CRUMP PLACE SUBDIVISION

The purpose of this application is to subdivide one lot into two lots.

APPLICATION NUMBER 14 DATE April 7, 2005

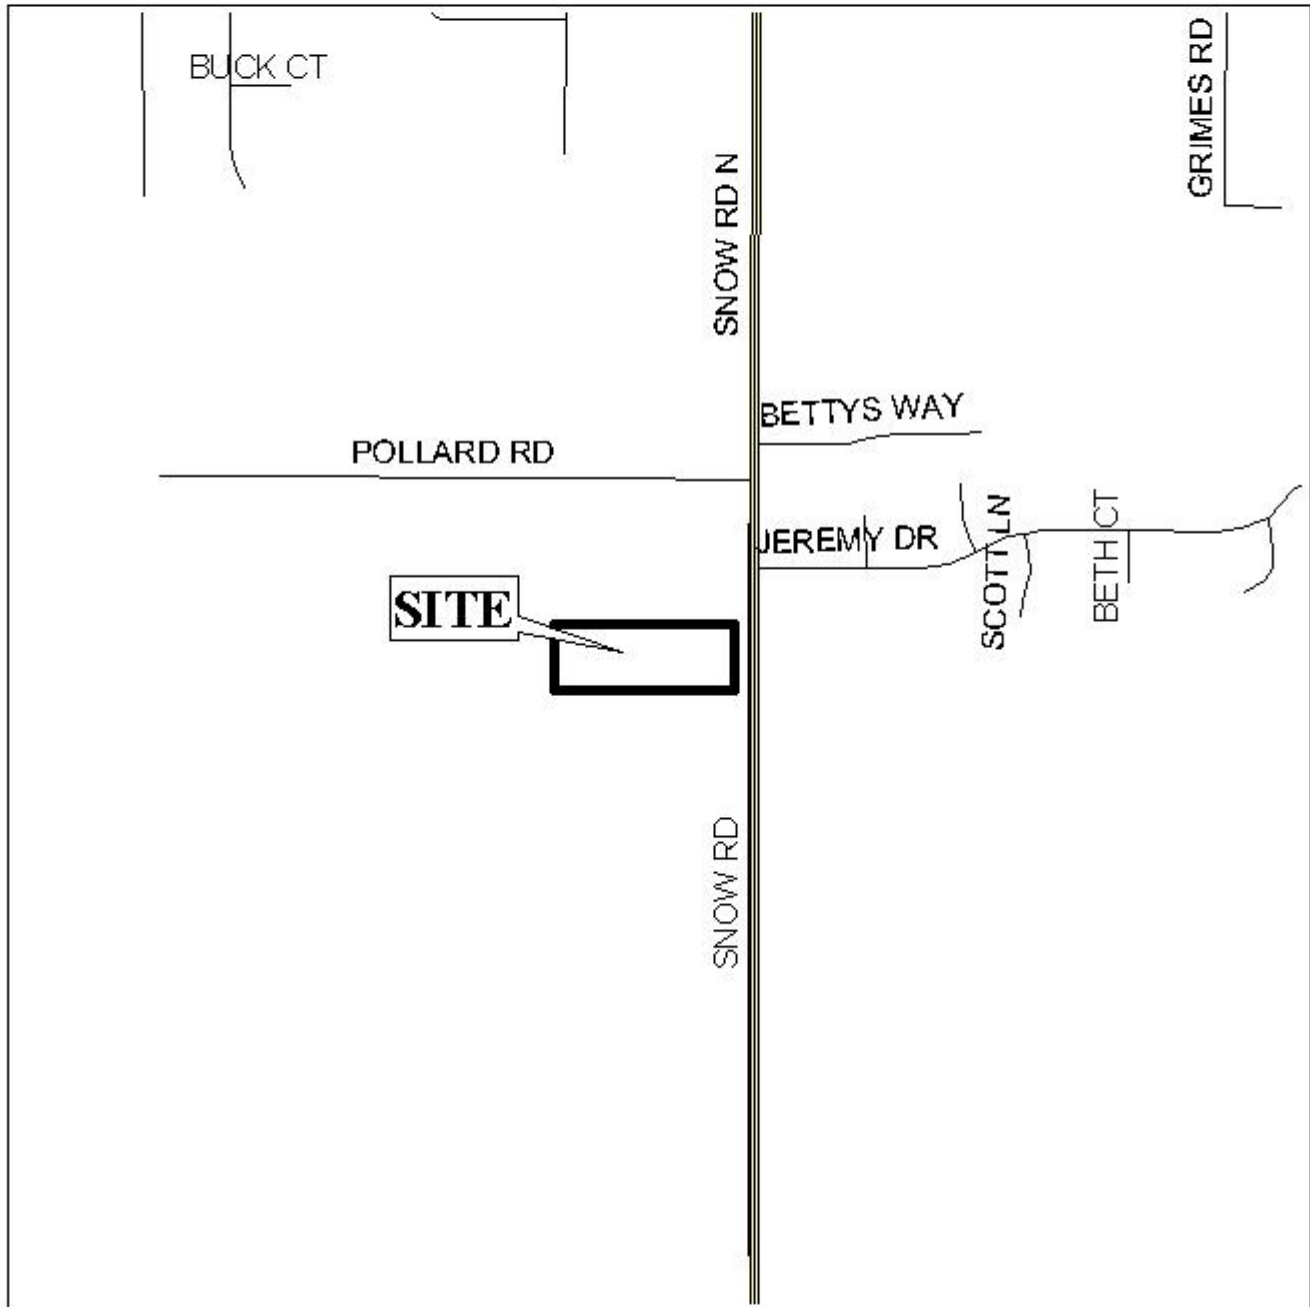
The site fronts Snow Road, a planned major street and the existing right-of-way is shown as 90-feet; the Major Street Plan requires a 100-foot right-of-way. Therefore, the provision of a 75-foot setback (which includes the required 25-foot minimum building setback) from the centerline of Snow Road, to provide for the right-of-way of the planned major street, should be required. Additionally, as a means of access management, the placement of a note on the final plat stating that Lots 1 and 2 are limited to one curb cut each to Snow Road, with the size, location and design to be approved by County Engineering, should be required.

As proposed, Lot 2 would exceed the maximum width to depth ratio of the Subdivision Regulations; therefore, a waiver of Section V.D.3. would be required. As the adjoining property to the North is a flag-shaped lot, the proposed plat could be considered characteristic of the surrounding area.

With a waiver of Section V.D.3. (width to depth ratio), the plat will meet the minimum requirements of the Subdivision Regulations and is recommended for Tentative Approval subject to the following conditions: 1) the provision of a 75-foot setback (which includes the required minimum building setback of 25-feet) from the centerline of Snow Road; 2) the placement of a note on the final plat stating that Lots 1 and 2 are limited to one curb cut each to Snow Road with the size, location and design to be approved County Engineering; and 3) the placement of a note on the final plat stating that any property that is developed commercially and adjoins residentially developed property shall provide a buffer, in compliance with Section V.A.7. of the Subdivision Regulations.
